ENGINE – INCORPORATE ROOT SEALING STRIPS ON STAGE 1.5, 2.0 AND 2.5 LPC BLADES –
CATEGORY CODE 6 – MOD.ENG-72-0017

V2500-ENG-72-0017

LP Compressor Stage 1.5, 2.0 and 2.5 blades - Before and after alteration
Fig.1

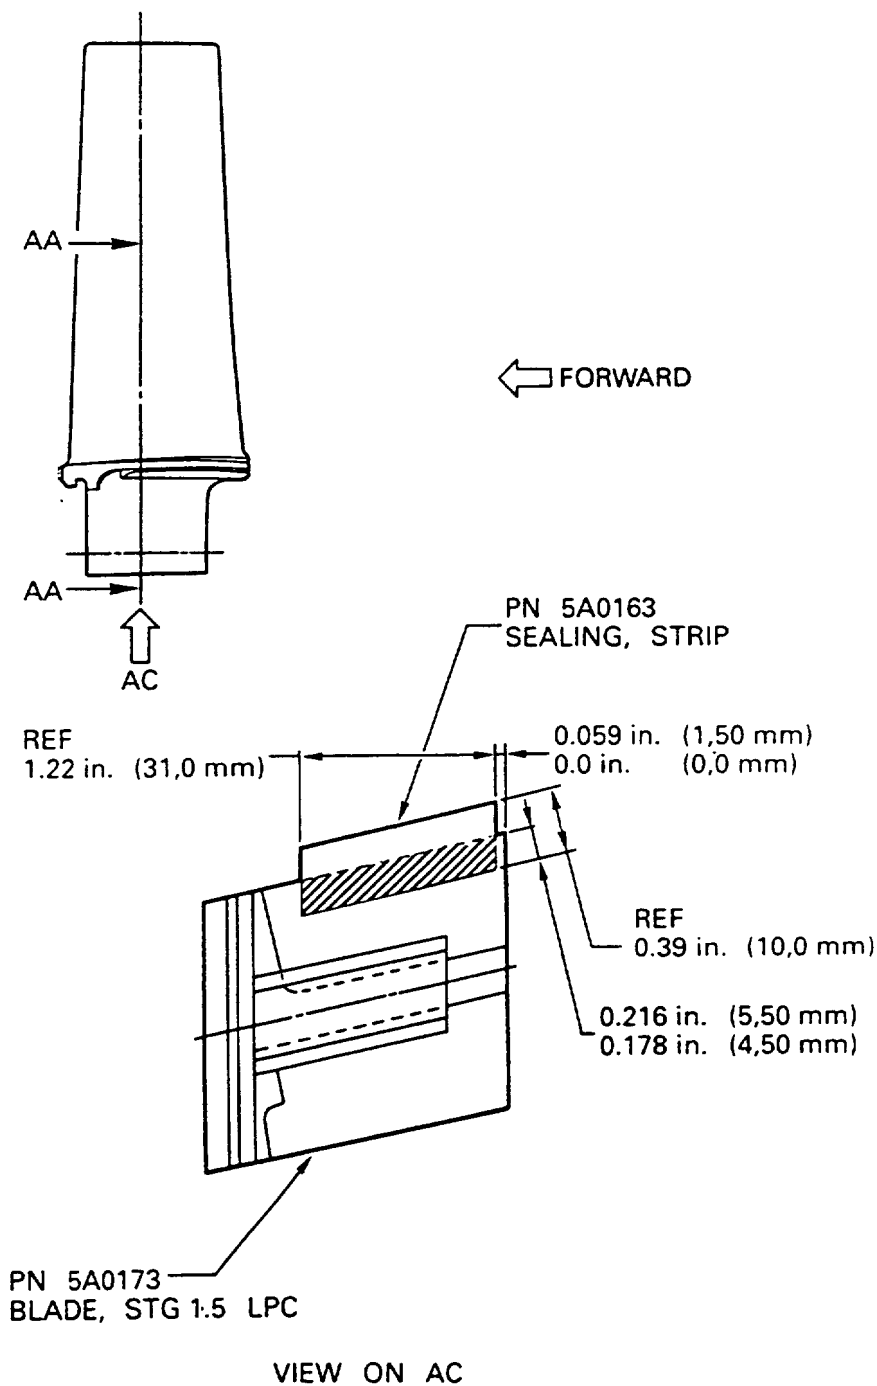
- (1) The changes introduced by this Service Bulletin are as follows:
 - (a) An Additional Sealing Strip is bonded to the Stage 1.5, 2.0 and 2.5 Blades LPC to prevent circulation of air flow. Refer to Figure 1.
- (2) Existing Blades on Stage 1.5, 2.0 and 2.5 must be replaced or reworked.
- (3) The new Blades on Stage 1.5, 2.0 and 2.5 will be available for future replacement purposes.
- (4) These changes must be accomplished as a complete set per engine.

To incorporate the improved blades with sealing strips to prevent air flow circulation.

Rework of the blades, Stage 1.5 LPC
Fig.2 (Sheet 1 of 3)

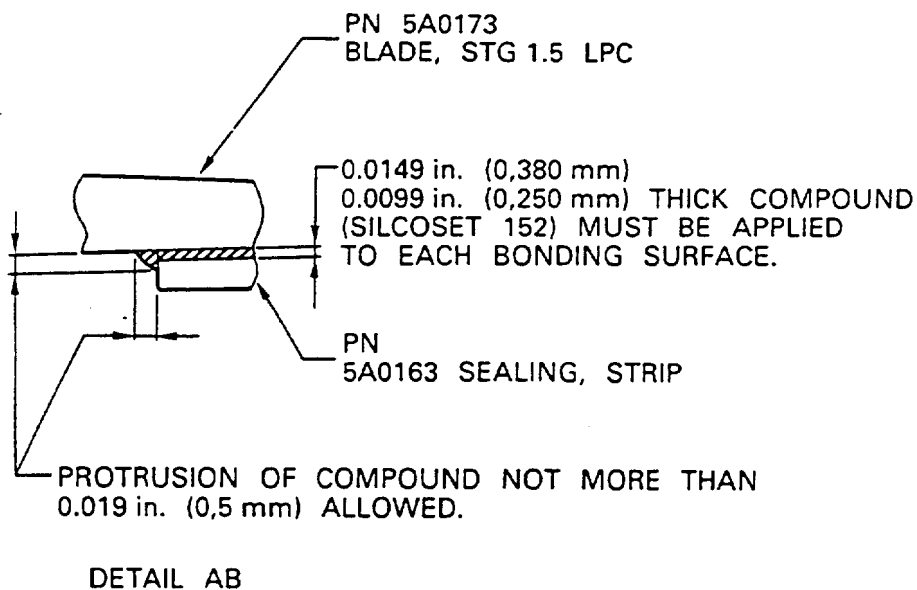
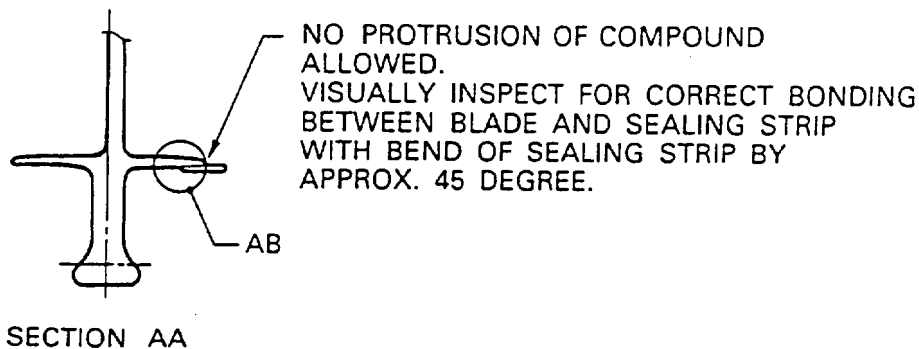
Procedure	Supplementary Information
(a) Degrease of the mating surfaces on each of 5A0173, 5R0023 and 5R7104 Blades and each of new 5A0163, new 5R0044 and new 5R0046 Sealing Strips, with CoMat 01-076, methylethyketone CH ₃ COCH ₃ , and CoMat 02-009, Lint free cloth	Refer to Figure 2 Sheets 1 and 2, Figure 3 Sheets 1 and 2, and Figure 4 Sheets 1 and 2. Refer to Overhaul Processes and Consumables Index

(b) Hand clean the mating surfaces on each of 5A0173, 5R0023 and 5R7104 blades, and each of new 5A0163, new 5R0044 and new 5R0046, sealing strips, with CoMat 05-016, garnet paper or CoMat 05-017, garnet paper	Refer to Figure 2 Sheets 1 and 2, Figure 3 Sheets 1 and 2 and Figure 4 Sheets 1 and 2. Refer to Overhaul Processes and Consumables Index

(c) Do step (a) again to degrease and remove contaminants	
(d) Let the surfaces dry for 25 minutes at room temperature	
(e) Apply a thin layer of CoMat 08-014, primer for Silcoset 151, 152, 153 to the mating surface on each of 5A0173, 5R0023 and 5R7104, blades with a brush. Dry in air for 30 minutes	Refer to Figure 2 Sheets 1 and 2, Figure 3 Sheets 1 and 2, and Figure 4 Sheets 1 and 2. Refer to Overhaul Processes and Consumable Index

Rework of the blades, Stage 1.5 LPC
FIG.2 (Sheet 2 of 3)

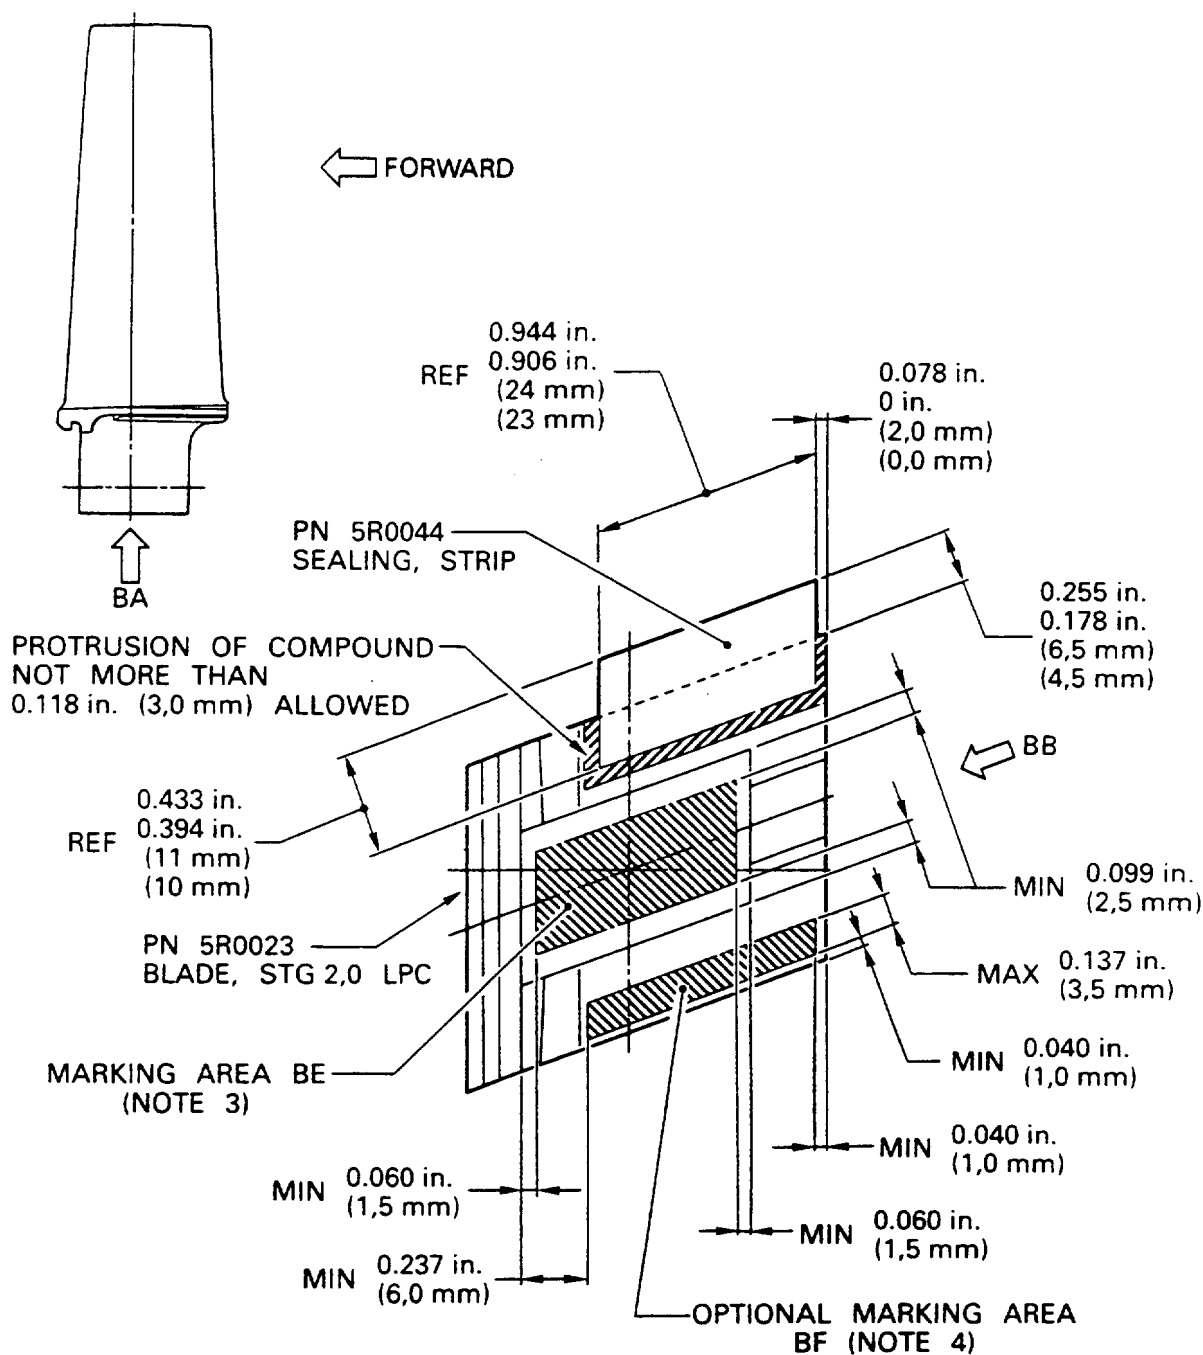
Refer to Figure 2 Sheet 2, Figure 3 Sheets 2 and 3 and Figure 4 Sheets 2 and 3 requirements

Refer to Figure 2 Sheet 2, Figure 3 Sheets 2 and 3 Figure 4 Sheets 1, 2 and 3.
Refer to Standard Practices/Processes Manual 70-09-00, Marking of Parts:

Rework of the blades, Stage 2.0 LPC
Fig.3 (Sheet 2 of 3)

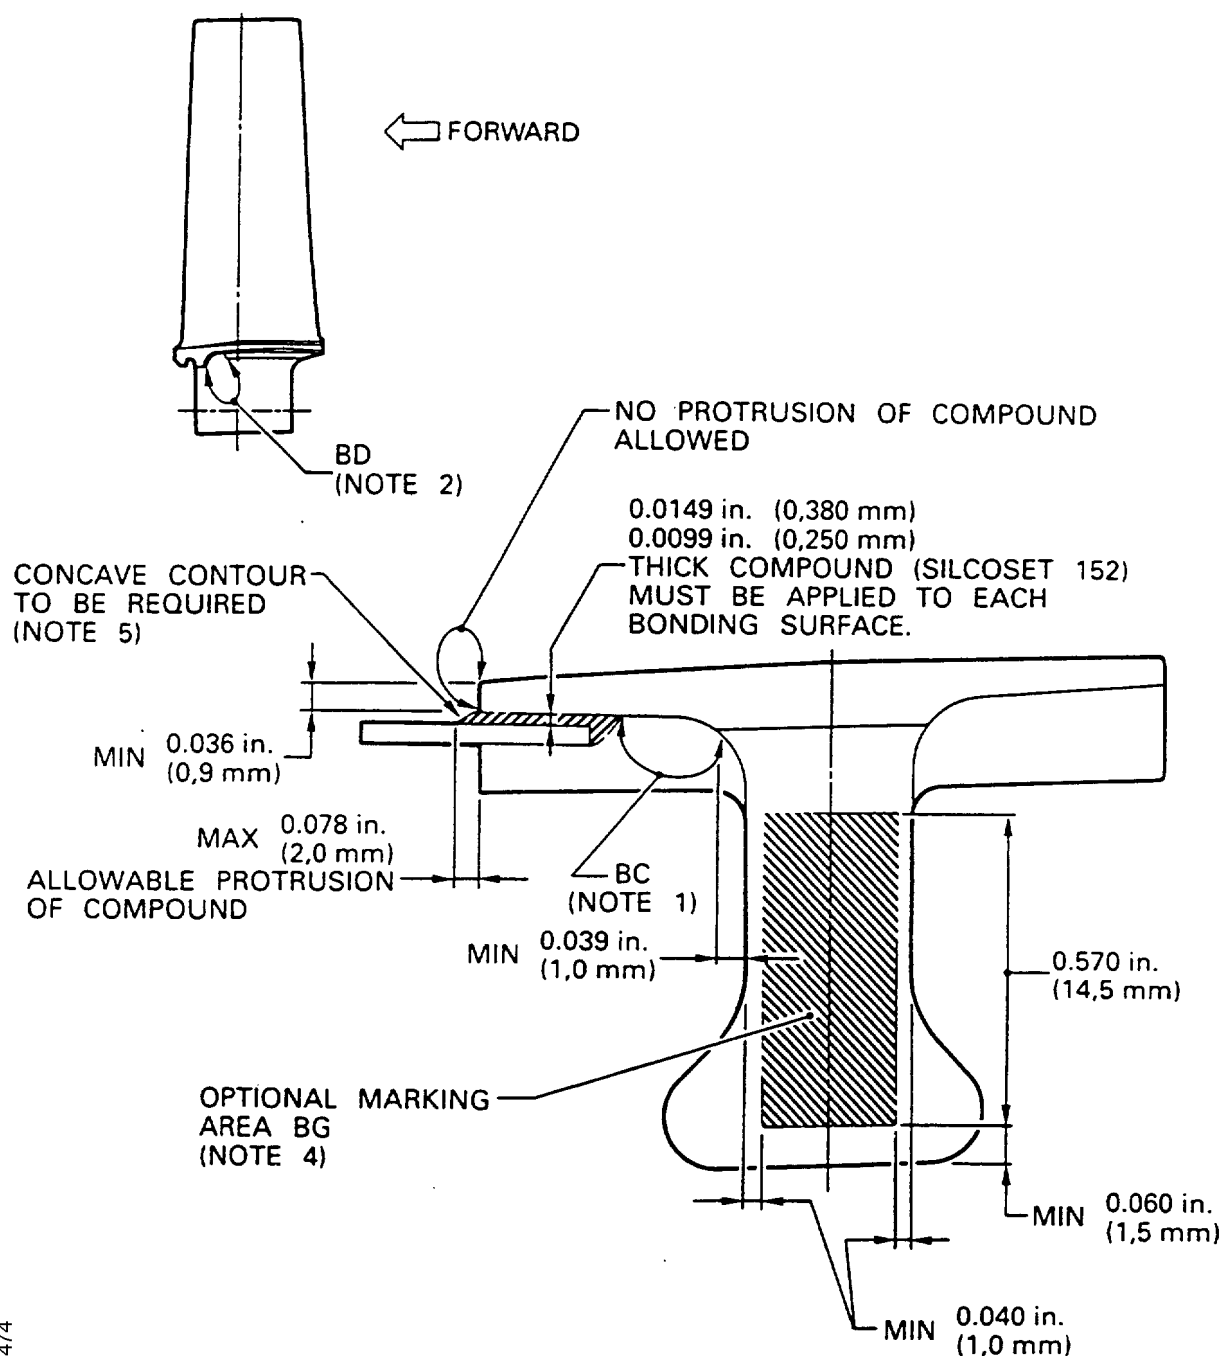
- NOTE:
- 1 MAX 0.0098 in. (0,25 mm) PROTRUSION OF COMPOUND IS ALLOWABLE ON ALL SURFACES OF SEALING STRIP AND AT BC.
 - 2 MAX 0.0098 in. (0,25 mm) PROTRUDED COMPOUND THICKNESS IS ALLOWABLE AT BD.
 - 3 MARK NEW PN 5R0045 FOLLOWED BY 'ASSY' AT BE BY VIBRO-PEEN ADJACENT TO EXISTING PART NUMBER.
 - 4 IF MARKING AREA BE DOES NOT HAVE SUFFICIENT SPACE TO MARK, AREAS BF AND BG CAN BE USED.
 - 5 VISUALLY INSPECT FOR CORRECT BONDING BETWEEN BLADE AND SEALING STRIP WITH BEND OF SEALING STRIP BY APPROX. 45 DEGREE.

Rework of the blades, Stage 2.5 LPC
Fig.4 (Sheet 2 of 3)

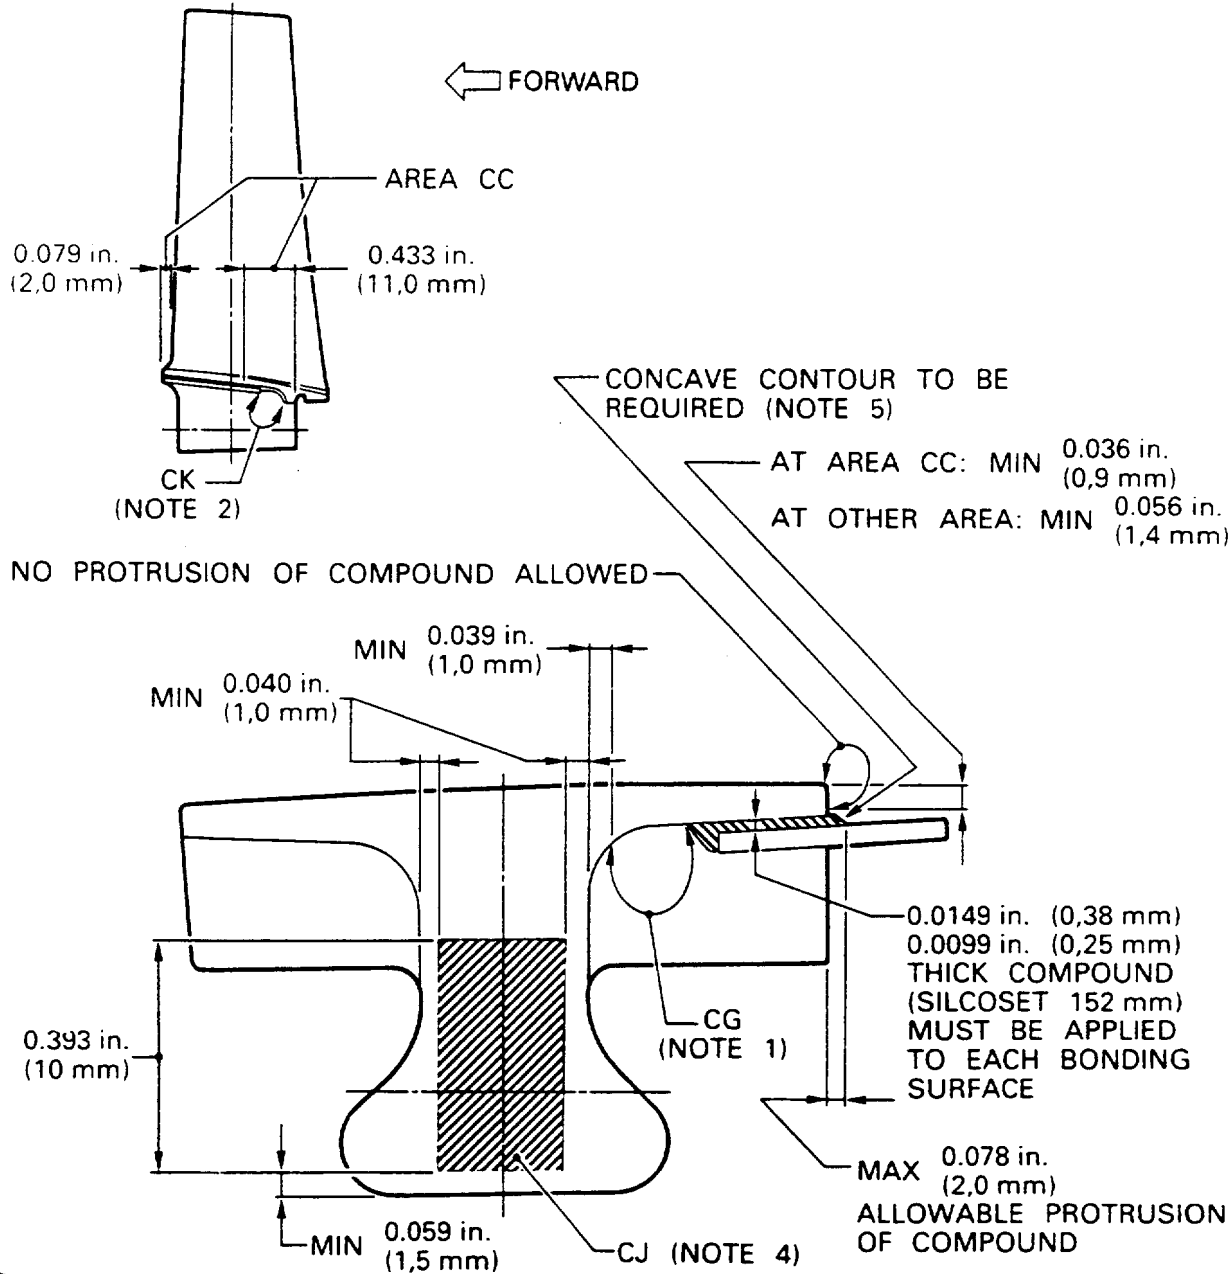
- NOTE:
- 1 MAX 0.0098 in. (0,25 mm) PROTRUSION OF COMPOUND IS ALLOWABLE ON ALL SURFACES OF SEALING, STRIP AND AT CG.
 - 2 MAX 0.0098 in. (0,25 mm) PROTRUDED COMPOUND THICKNESS IS ALLOWABLE AT CK.
 - 3 MARK NEW PN 5R0045 FOLLOWED BY 'ASSY' AT CE BY VIBRO-PEEN ADJACENT TO EXISTING PART NUMBER.
 - 4 IF MARKING AREA CE DOES NOT HAVE SUFFICIENT SPACE TO MARK, AREAS CH AND CJ CAN BE USED.
 - 5 VISUALLY INSPECT FOR CORRECT BONDING BETWEEN BLADE AND SEALING STRIP WITH BEND OF SEALING STRIP BY APPROX. 45 DEGREE.
